Video Products
Service Bulletin

Model: SLV-353UC/373UC/555UC/575UC/676UC/
757UC/P33/R5UC

No. 152

Subject: Does Not Load Cassette

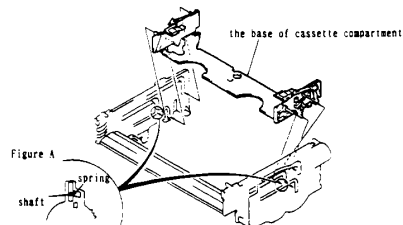
- ① Engage the axles (six places) of the base of the cassette compartment in the grooves of the side board of the cassette compartment. (See Figure A).
